STATE OF DELAWARE
DEPARTMENT OF TRANSPORTATION
800 BAY ROAD
P.O. BOX 778
DOVER, DELAWARE 19903

February 17, 2009

DeIDOT Contract Number: 95-090-01; Federal Aid Project Number: IM-N056(27)
I-95 Delaware Turnpike Improvements Project
I-95/SR 1 Interchange/I-95 Turnpike Mainline
Turnpike Mainline from SR 1 to SR 141; I-95/SR 1 Interchange; I-95 Northbound
Widening Extension
New Castle County, Delaware
Environmental Reevaluation [*Change in interchange design*]

The current reevaluation details modifications in the design of the I-95/SR 1 interchange portion of the project. The design changes are being incorporated into the project to provide additional traffic operational and safety improvements within the interchange. An environmental evaluation of the currently proposed design has been completed, and the changes would increase the impacts to wetlands by an additional 0.26 acres. Mitigation for this additional impact will be accommodated within the Cathcart wetland mitigation site (identified as Site 7 in the

January 2009

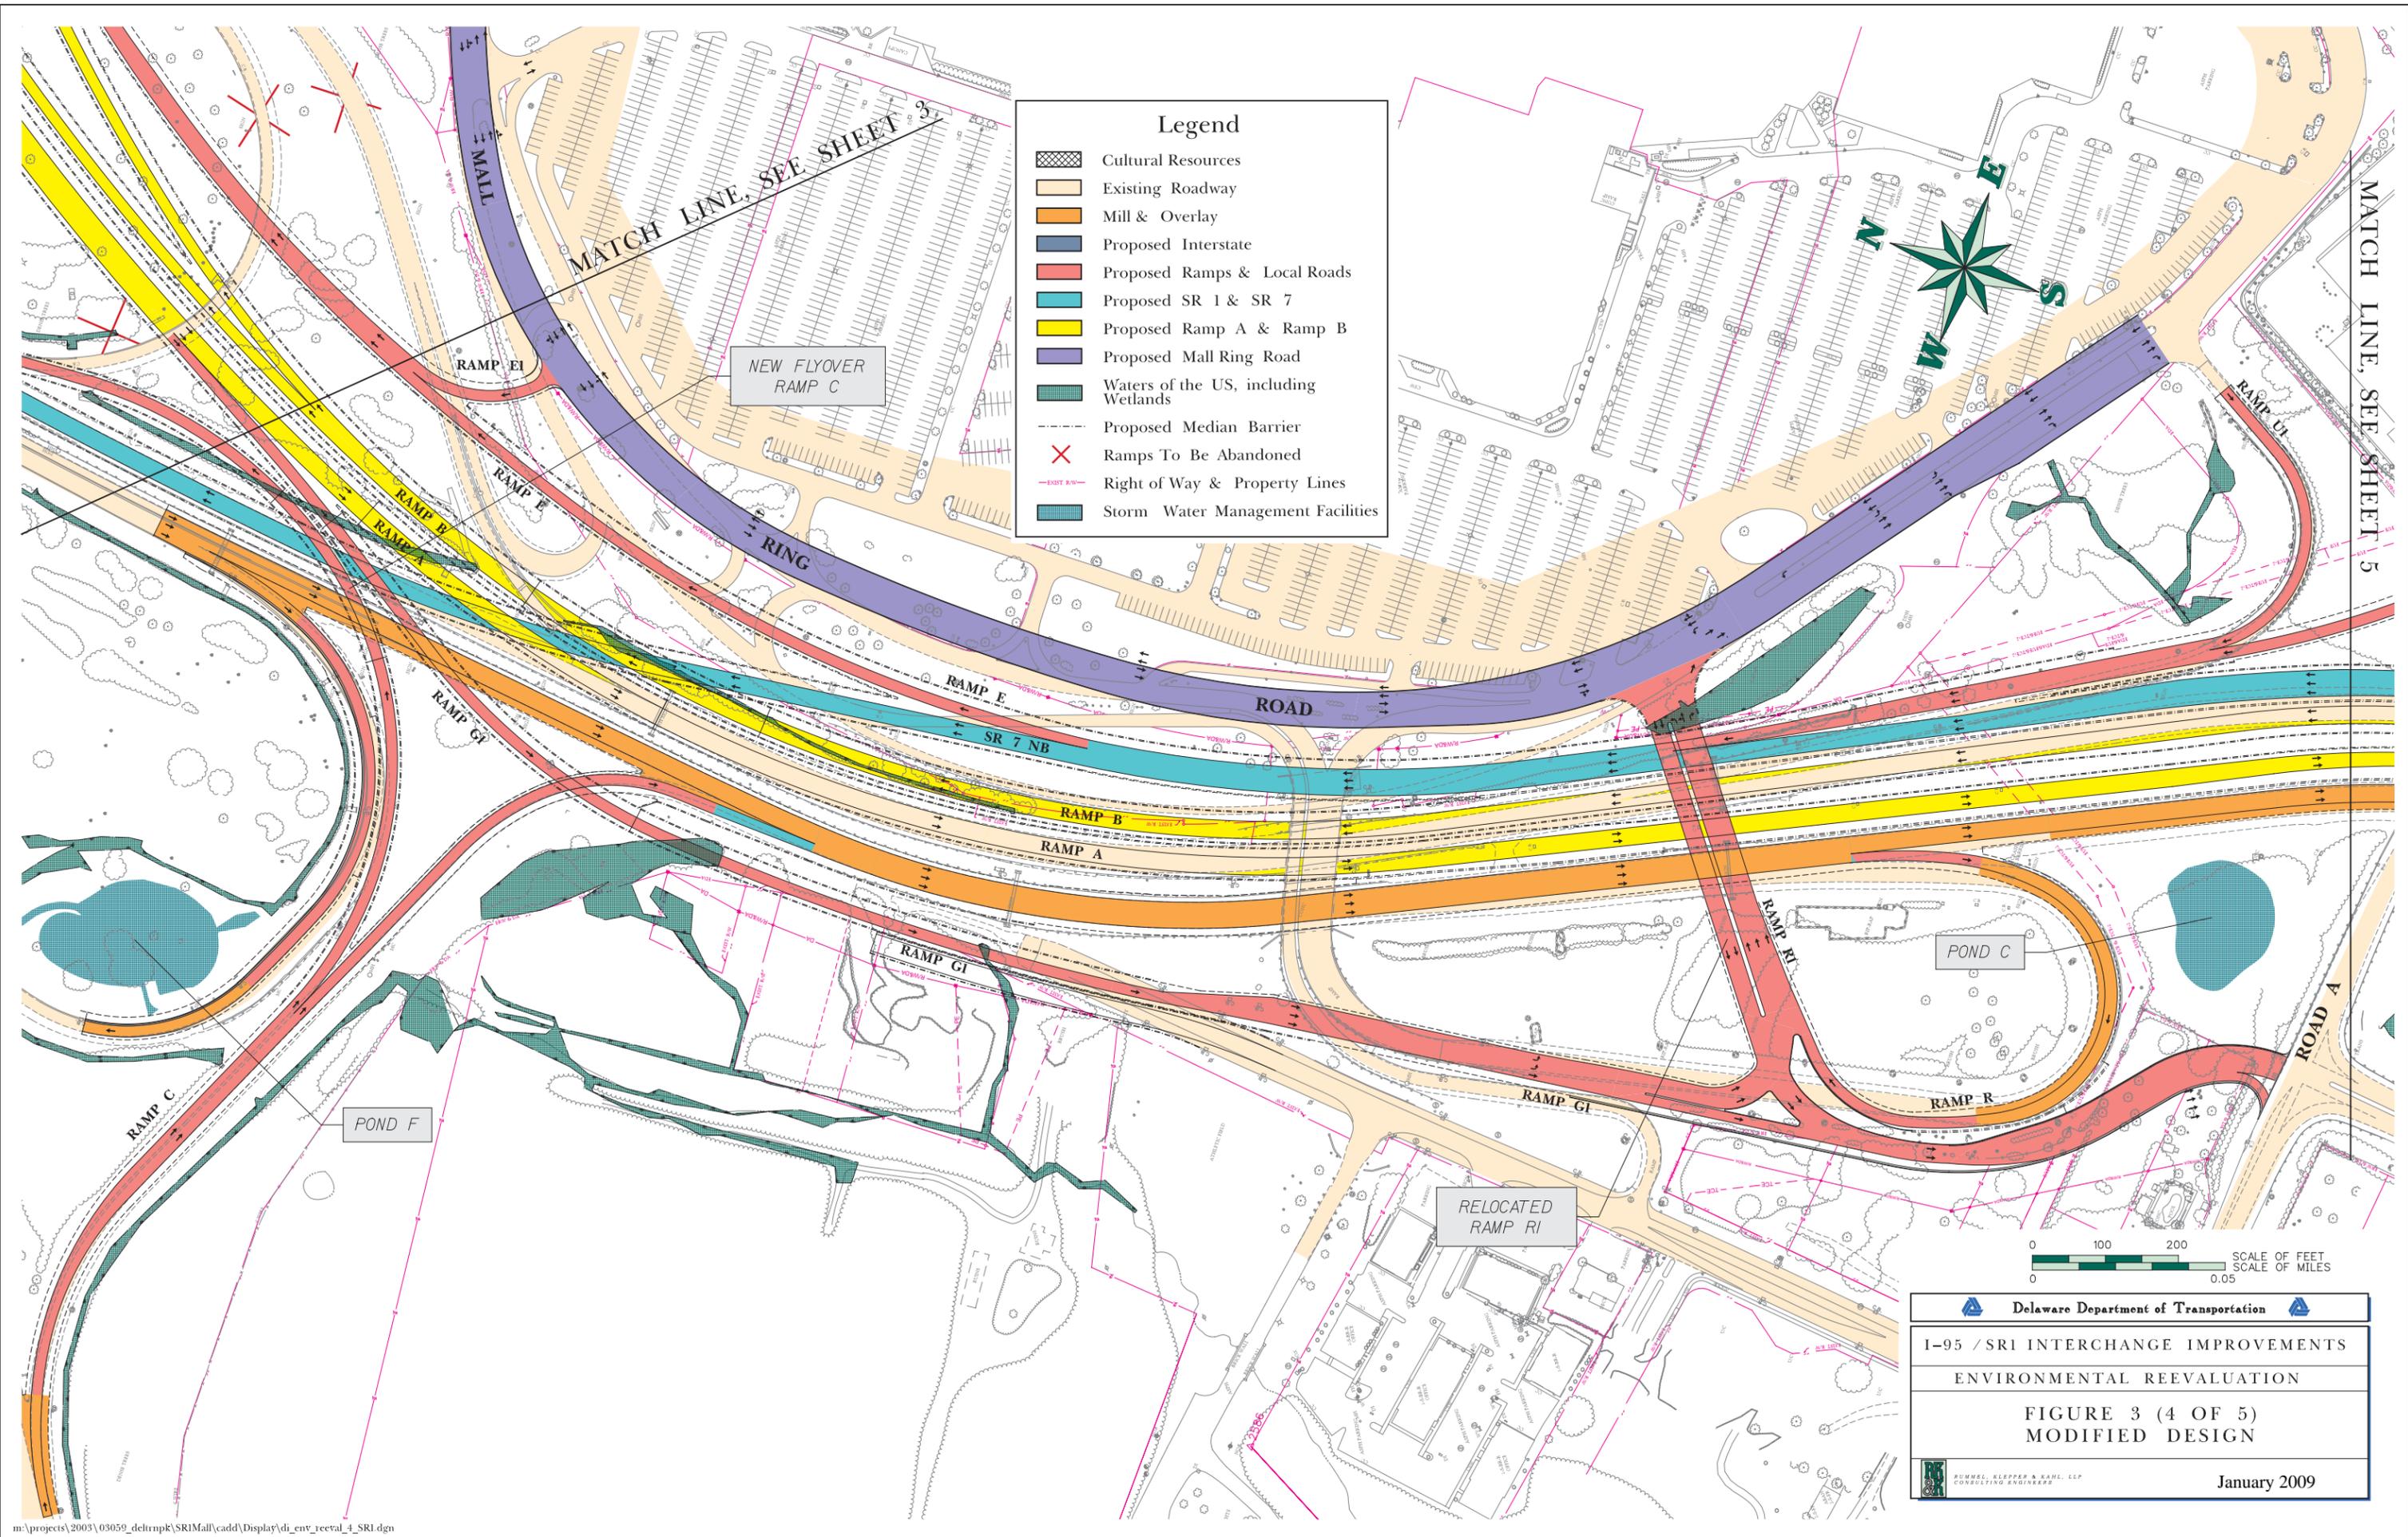
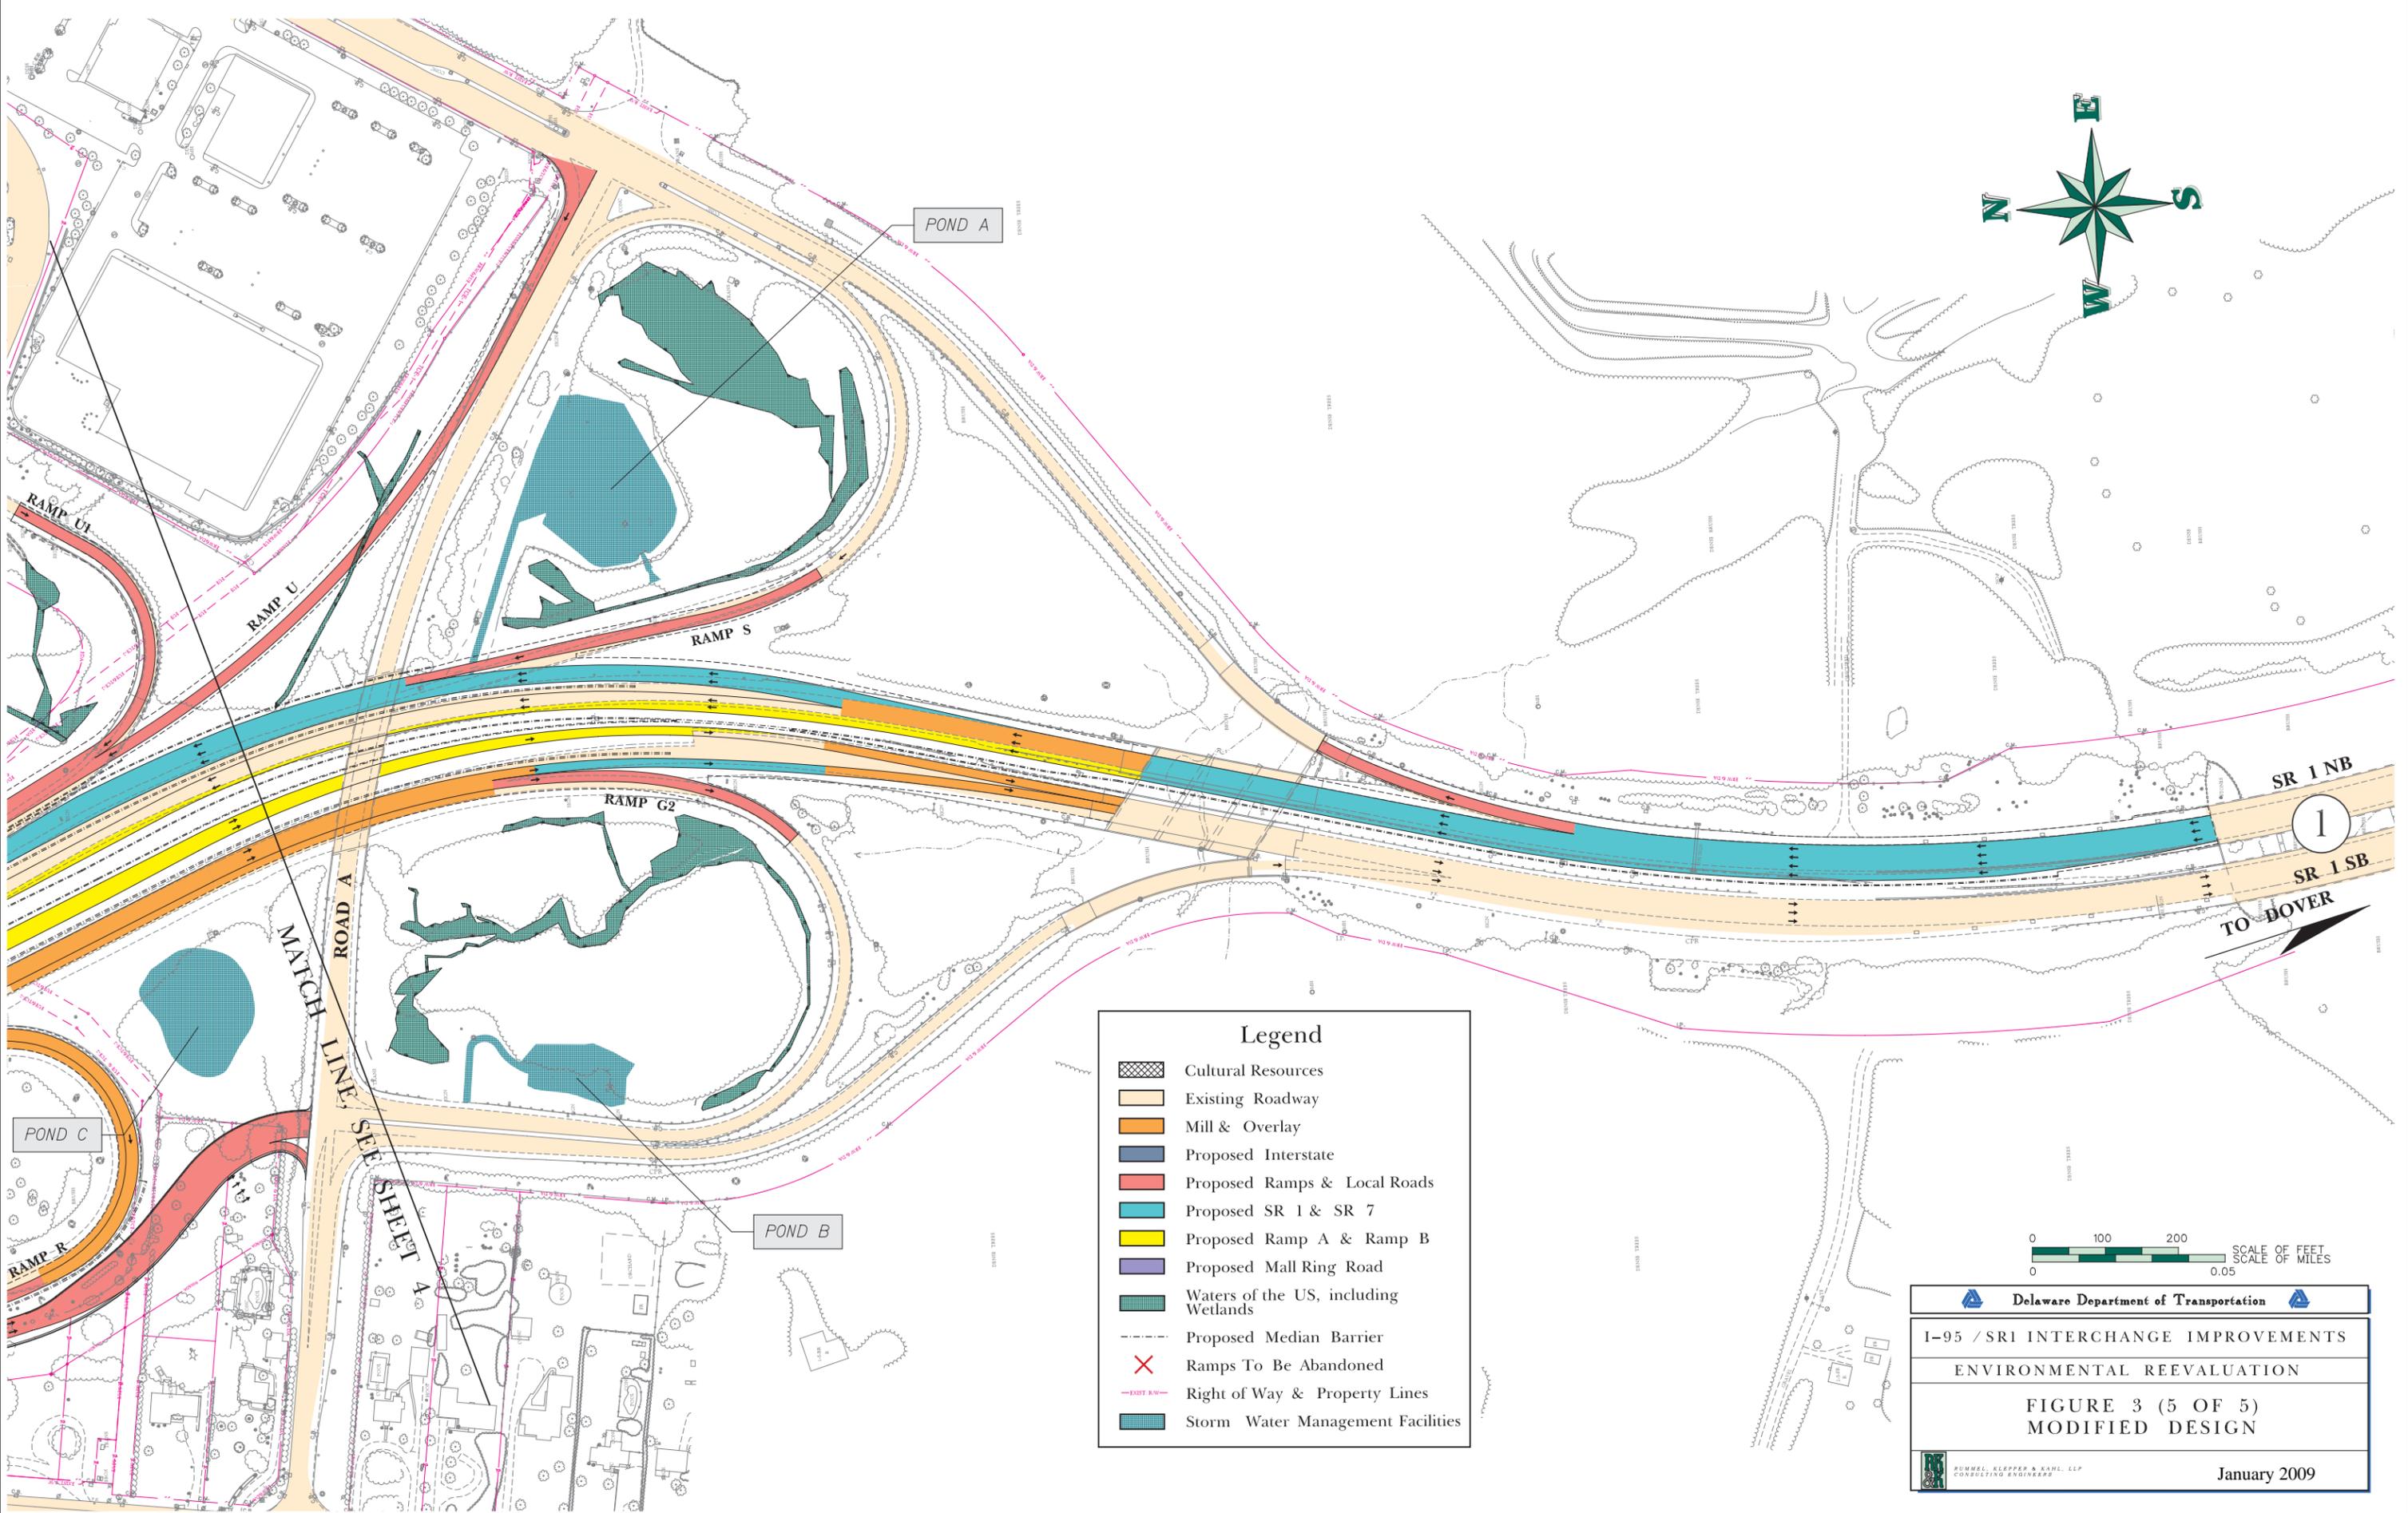
- The existing southeast quadrant loop ramp (from I-95 northbound to SR 7 northbound) has been eliminated and replaced by a semi-directional flyover ramp (identified on **Figure 3** as Ramp C) that extends from the southwest outer ramp from northbound I-95, passes over SR 7 and merges with northbound SR 7.

- The existing northbound lanes of I-95, north of the interchange, are shifted approximately 40 feet to the outside to accommodate Ramp B, which will fly over northbound I-95 and extend as the median lane of I-95.
- Ramp B (SR 1 northbound to I-95 northbound) will split in the vicinity of the southwest quadrant. The left lane will fly over northbound I-95, and become the median lane of the northbound I-95 mainline, as noted above. The right lane of Ramp B (Ramp B1) will extend along the outside of existing northbound I-95 and remain barrier-separated from the northbound I-95 mainline until north of the Churchmans Road bridge, where the lane merges with the existing outside mainline lane.
- The ramp (Ramp R1) to/from the Christiana Mall Road will be relocated approximately 150 feet south of its present location.

- The relocation of the Ramp R1 bridge approximately 150 feet to the south will allow for a lower profile for the ramp bridge and the reconstructed Christiana Mall Road, thus reducing the impact to the mall parking lot and eliminating a proposed retaining wall. Shoulder reductions in some areas have been reduced from 16/24 feet to 12 feet to accommodate the changes and avoid additional property acquisition from the Mall.
